Office Action Summary	Application No. 10/538,542	Applicant(s) AEBI ET AL.	
	Examiner MICHAEL T. SCHAPER	Art Unit 3775

DETAILED ACTION

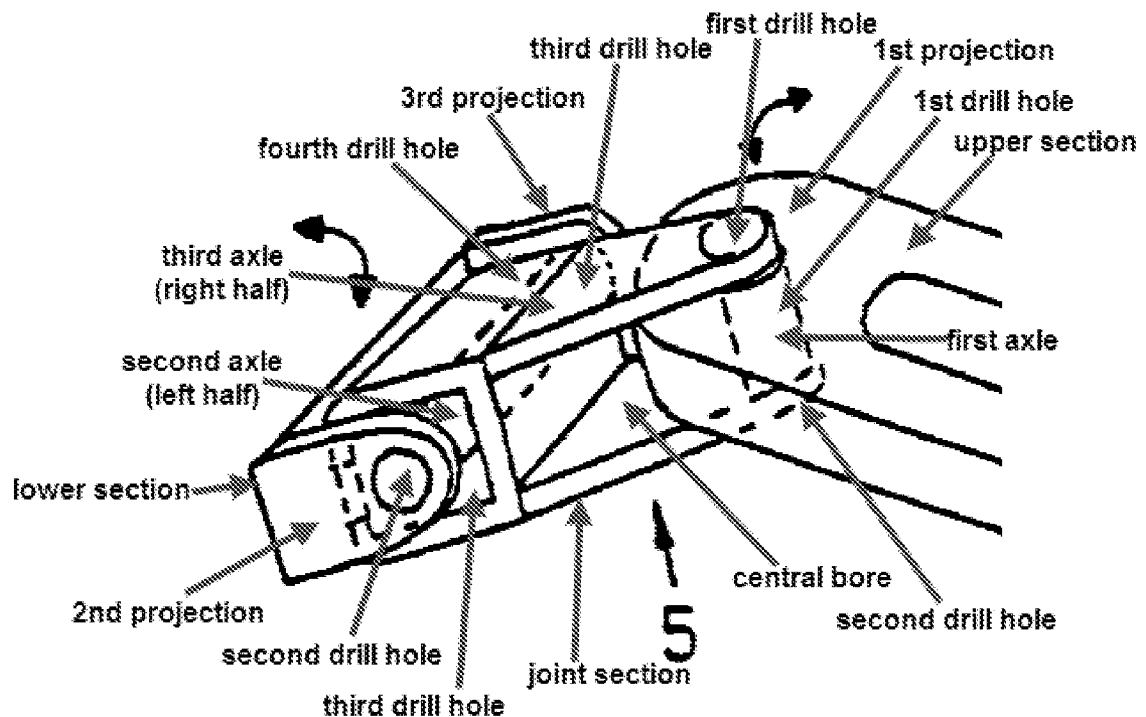
Stranders discloses a universal joint (see examiner-annotated FIG. 2 above) wherein the upper section having a first projection extending from the bottom surface, the first projection including a first drill hole; the lower section having second and third projections extending from the top surface, the second and third projections including second and third drill holes, respectively; and a frame shaped, central joint section located between the upper and lower sections so that the upper section is moveable with respect to the lower section, the central joint section including a central bore and first, second, third and fourth drill holes, the first projection extending from the bottom surface of the upper section being receivable within the central bore formed in the central joint section, the central joint section being receivable between the second and third projections extending from the top surface of the lower section so that a first axle is receivable in the first and second drill holes formed in the central joint section and the first drill hole formed in the first projection, a second axle is receivable in the third drill hole formed in the central joint section and the second drill hole formed in the second projection and a third axle is receivable in the fourth drill hole formed in the central joint section and the third drill hole formed in the third projection.
